KIT NO. 1068356

Brush Motor Replacement Kit

5700/XP/XPS - 800HD, 900D Disk Models

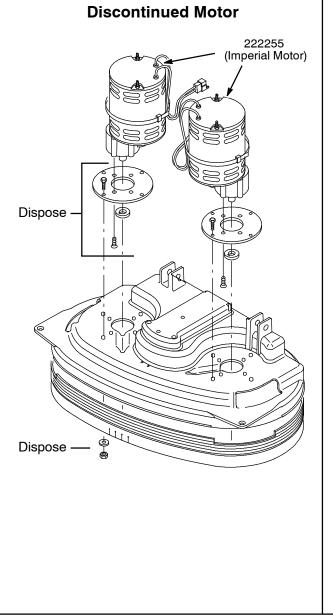
NOTICE: Brush Motor (p/n 222255) has been discontinued and replaced by this motor kit. Install replacement motor kit as illustrated below at right.

Motor Replacement Kit (p/n 1068356) **IMPORTANT:** For proper motor alignment, position motors as shown below. For early scrub decks, the motor mount hole pattern may not accept replacement motor. A new scrub deck will be required. Contact Service. 1063463 (Amer Motor) 3 Adapter Plate & Spacer Ring not required
